RUN CHANGES

SCHMATIC FOR 8L3, 8L3A AMPLIFIER - POWER SUPPLY CHASSIS

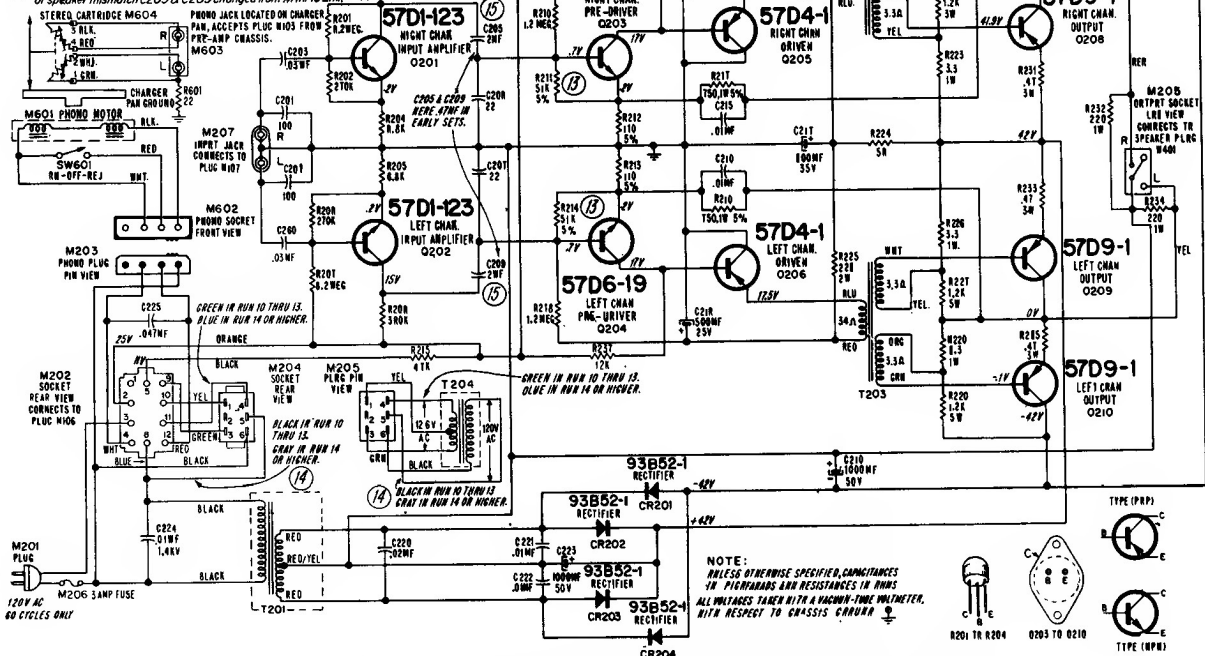
(13) For reduced background noise, R211 & R214 changed from 62k to 51k, 5%. Q203 & Q204 changed from 57D1-124 to 57D6-19.

(14) For proper phase relation of AC leads with resulting reduction of hum at max. volume levels, T204 & M204 lead color code changed as shown on schematic.

(15) To eliminate possibility of low frequency motor boating in case of speaker mismatch C205 & C209 changed from 47mf to 2mf.
